Mapleton City

Planning Commission Staff Report

HIDDEN LANE ESTATES PLAT "A"

HIDDEN LANE ESTATES
PRELIMINARY PLAT

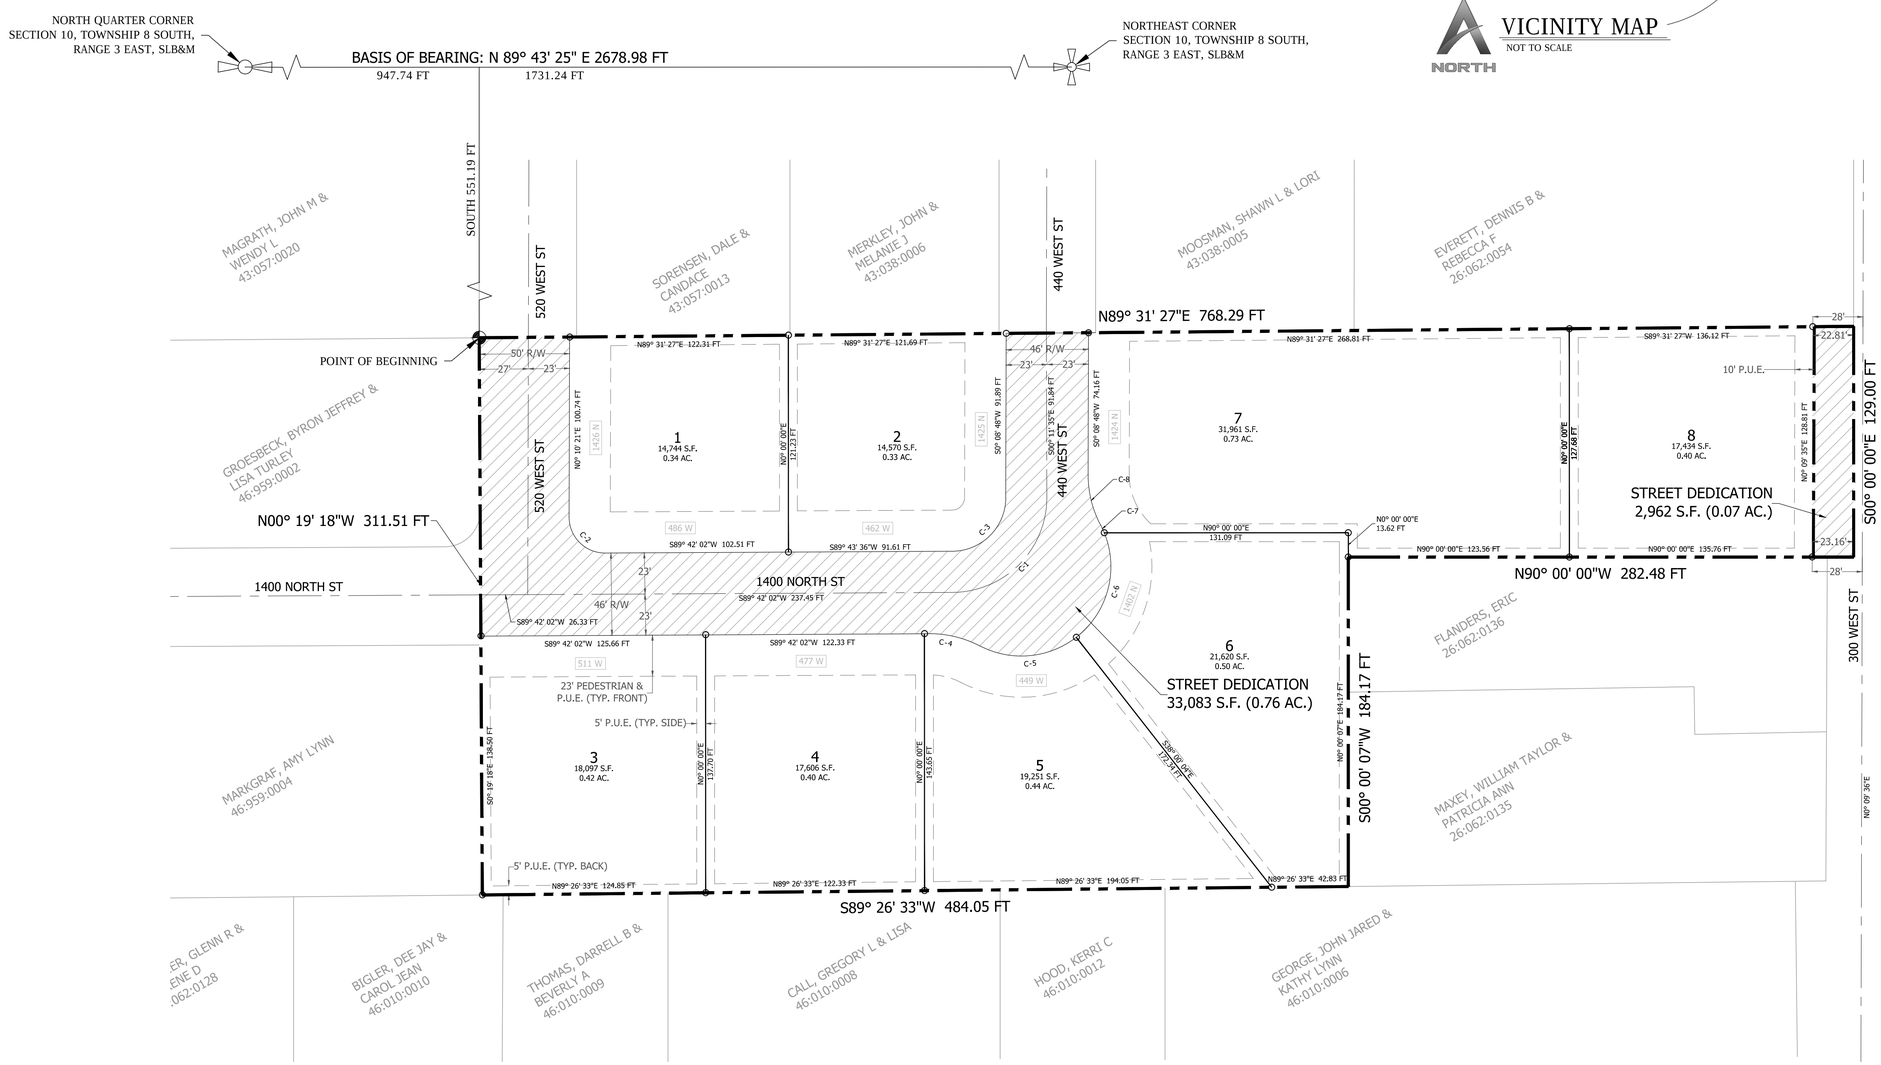
1. **Lots 1 and 2 do not contain the required 14,500 square feet. The subdivision cannot be approved until the lots meet the minimum area requirement.***

2. The final plat must include, among other requirements, the following:
    a. A final plat stamped and signed by the Surveyor of Record.
    b. A dedication block and signature lines for all property owners. The owners will need to sign the plat exactly as they signed the deed to the property and must print their names underneath their signatures to match the signatures. In addition, properties in trusts must include the title of the signer, the full name of the trust and the date of the trust.

c. The owners dedication must be accompanied by a line for the notary sign the plat, a line for the notary to print their full name, their commission number and the words “A notary public commissioned in Utah” in the signature block.

d. Addresses must be shown on the final plat. The assigned addresses are attached to these DRC minutes.
    e. Street coordinates must be shown on the plat. If street names are to be used they must also be indicated on the plat

f. In accordance with the standards of the Utah County Recorder, a space must be reserved near the bottom right hand corner for the recording certificate to be printed

on the plat. The current plat doesn't make enough space for this certificate and the space provided is not in the correct location. Please communicate with the Utah County Recorder's Office for the specifics for this requirement.

g. In accordance with the standards of the Utah County Recorder, the names of the Owners must be printed in the Acknowledgement as the persons who appeared before the notary. It is useful for the plat to contain a space within the acknowledgment text for the names to be written. Other standards may apply for trusts and corporations. Please communicate with the Utah County Recorder's Office for the specifics for this requirement.

3. Boundary line gaps exist along the south and east property lines. These need to be resolved prior to recording the plat.
4. The applicant must show that lots 3 and 5 meet the minimum width requirement of 100'. The width measurement is made at the building line. The front yard setback is 30'. Provide a diagram with a measurement that shows that the minimum width is met at the setback/building line.

DRAWING: C-1

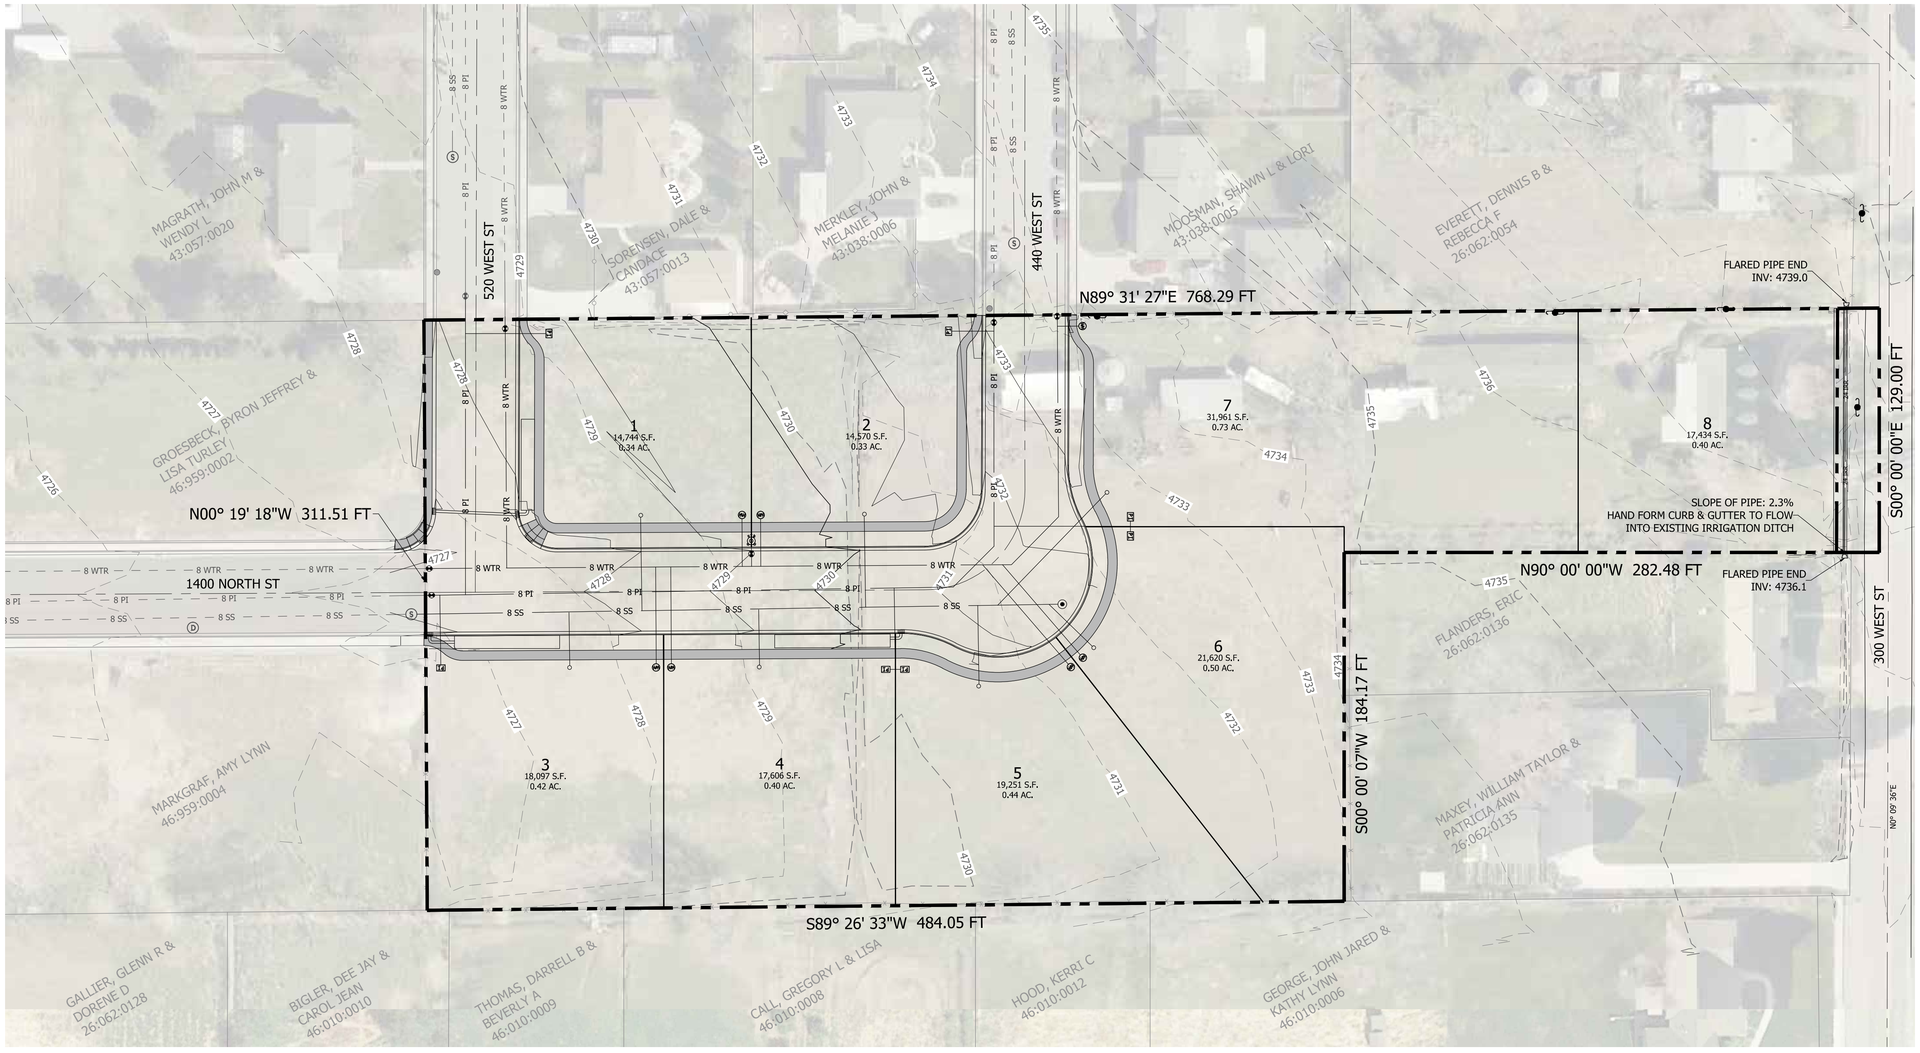
1. Please show pressurized irrigation system.

1. Please use updated city standard drawings.
2. Please remove typical pedestrian ramp detail and refer to latest APWA standards.
